ECE/TRANS/SC.3/WP.3/2010/4
2 December 2009

**RESOLUTION NO. 61, “RECOMMENDATIONS ON HARMONIZED EUROPE-WIDE
TECHNICAL REQUIREMENTS FOR INLAND NAVIGATION VESSELS”**

Amendments to Chapter 15, “Special provisions for passenger vessels”

Note by the secretariat

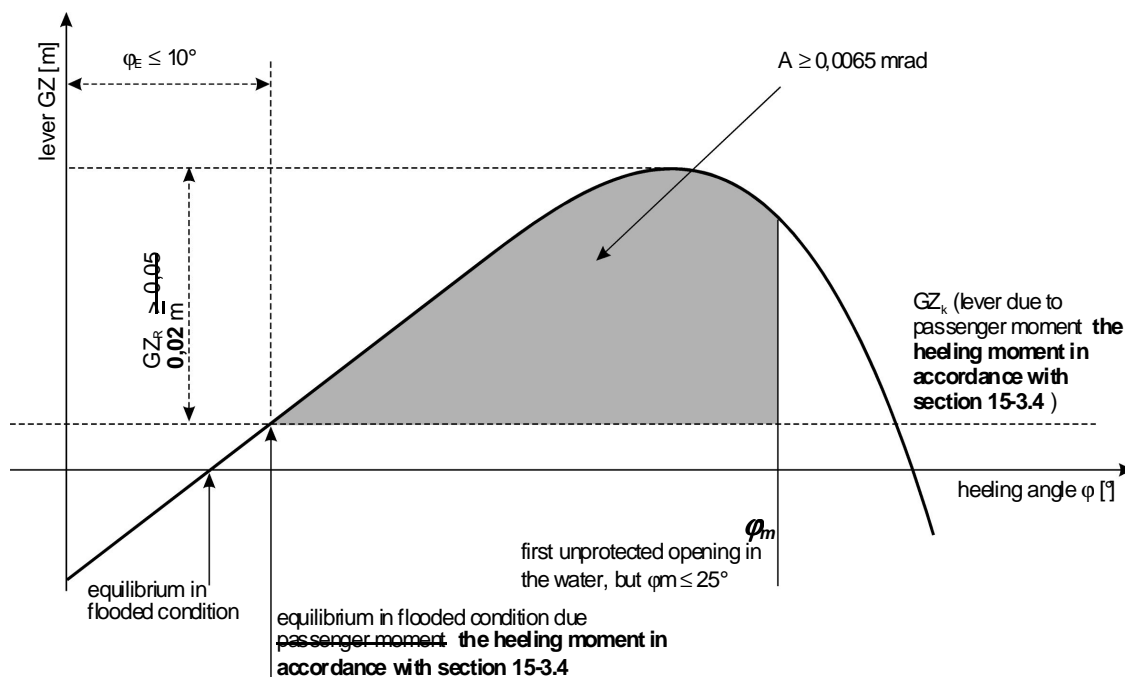
- (j)
- Amend
- paragraph 15-3.11 (ii) as follows

beyond the equilibrium position the positive part of the righting lever curve shall display a righting lever value of $GZR \geq 0,02$ **0,05** m with an area $A \geq 0,0065$ **0,0025** m·rad. These minimum values for stability shall be met until the immersion of the first unprotected opening or in any case before reaching a heeling angle ~~$\phi_m \leq 25^\circ$~~ **ϕ_m of 25°**;

(k) Move the graphic from 15-3.11 (iii) to 15-3.11 (ii) with the following modifications¹¹

Where:

ϕ_E is the heeling angle in the final stage of flooding taking into account the moment in accordance with section 15-3.4;

ϕ_m is the angle of vanishing stability or the angle at which the first unprotected opening immerses or 25°; whichever is less is to be used;

GZR is the remaining righting lever in the final stage of flooding taking into account the moment in accordance with section 15-3.4;

GZK is the heeling lever resulting from the moment in accordance with section 4;
